DEVELOPMENT APPLICATION ASSESSMENT REPORT

Application Number:	DA2021/2034
----------------------------	-------------

Responsible Officer:	Adam Croft
Land to be developed (Address):	Lot 50 DP 705739, 30 Fairlight Street FAIRLIGHT NSW 2094
Proposed Development:	Demolition works and construction of a residential flat building
Zoning:	Manly LEP2013 - Land zoned R1 General Residential
Development Permissible:	Yes
Existing Use Rights:	No
Consent Authority:	Northern Beaches Council
Delegation Level:	NBLPP
Land and Environment Court Action:	Yes
Owner:	30 Fairlight Pty Limited
Applicant:	30 Fairlight Pty Limited

Eastern Elevation

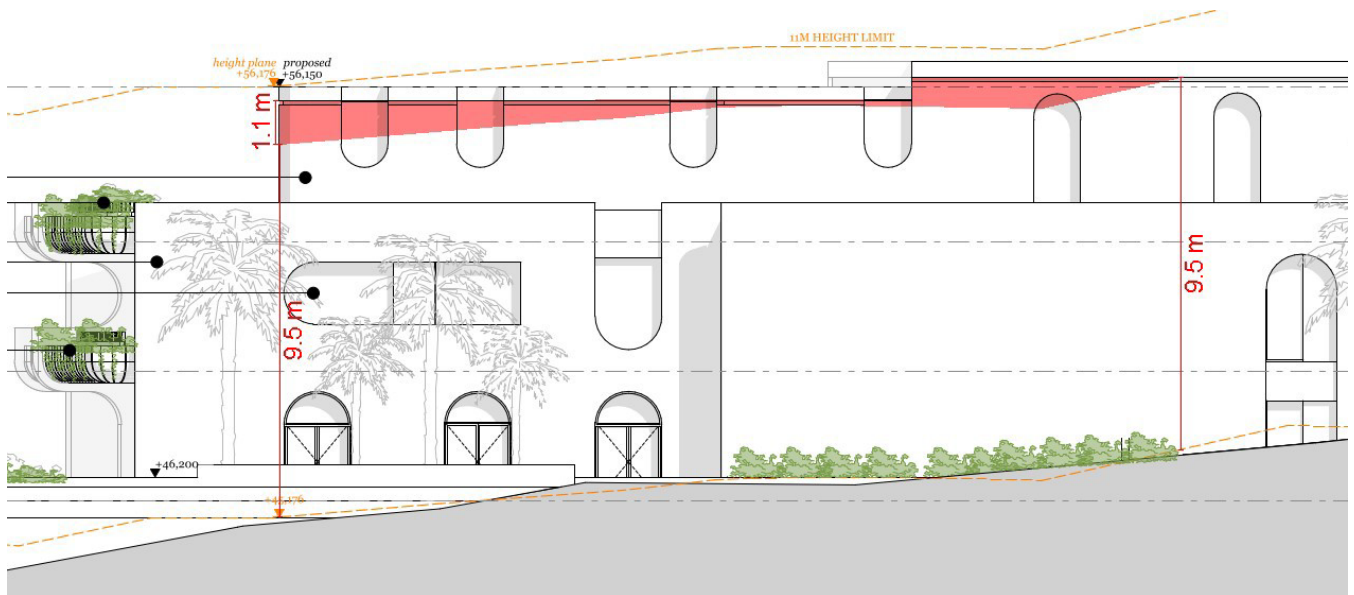
Clause 4.1.2.1 permits a maximum wall height of 9.5m for the site. The proposed Level 2 exceeds the control up to a maximum height of 10.6m at the eastern elevation and 10.3m at the western elevation. The extent of the wall height breaches are indicated on the below plans:
